Block 20a EDMONDSON PARK AFFORDABLE HOUSING

RESPONSE TO KEY ISSUES

Project Address Lot 401, Lot 402, Cnr MacDonald Rd +
 Buchan Ave, Edmondson Park, NSW 2174
Project Number 2518
Phase State Significant Development Application
Version -
Date Issued 27.07.2026
Prepared by CH
Checked by AA

Version	Amendment	Date
-	Response to DPHI Key issues	27.07.2026

Updated basement plan

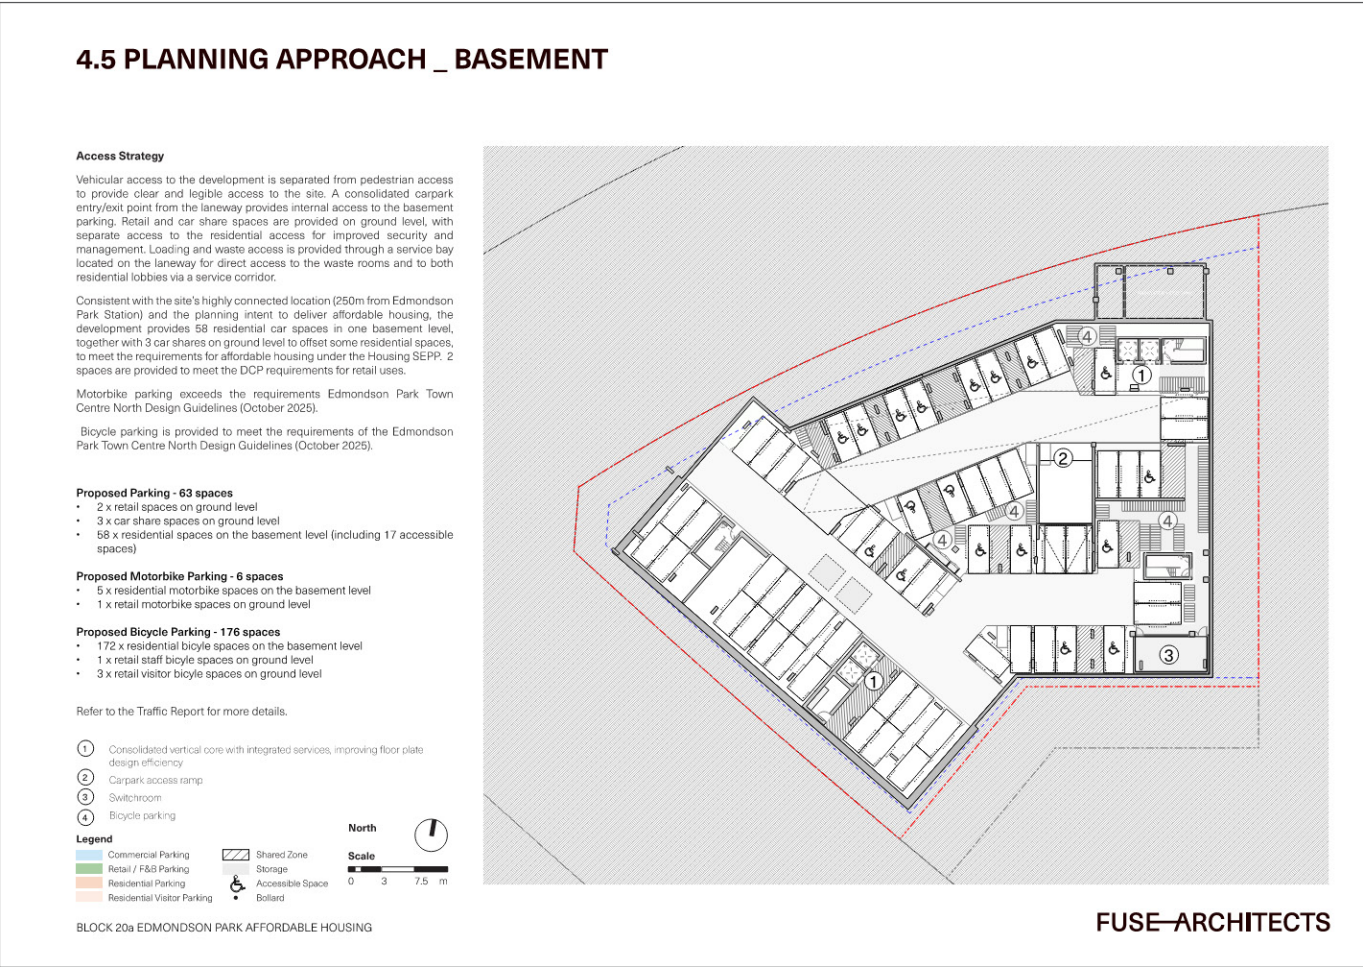
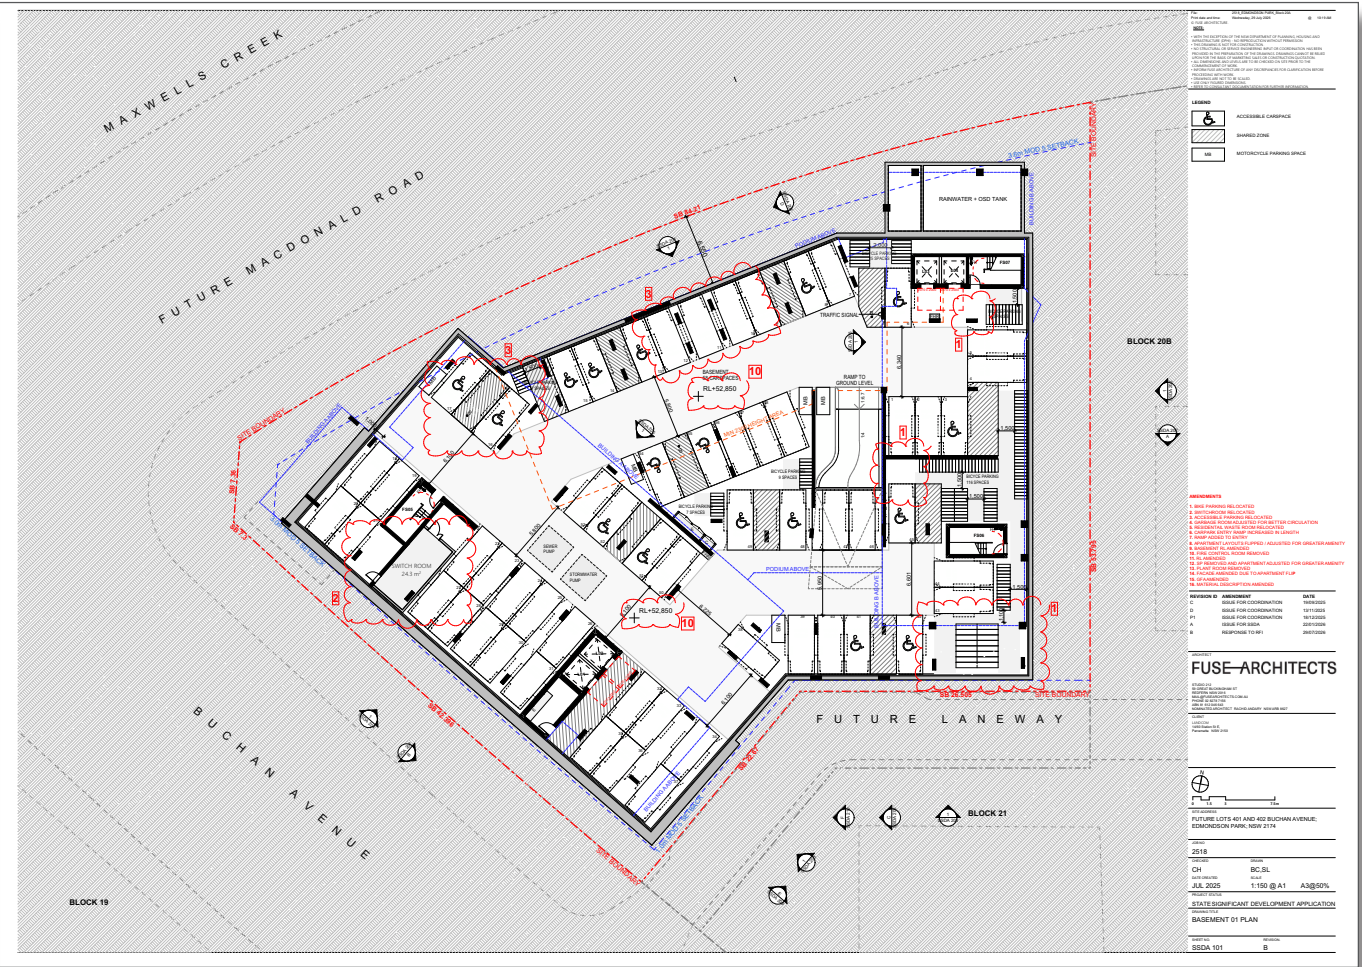
Inconsistencies have been identified between the Design Report and Basement 01 Plan regarding the location of the switch room, bicycle parking and storage. The Department requests clarification and consistency across all documentation on the location of these components.

Inconsistencies have been checked and corrected across all documentation.
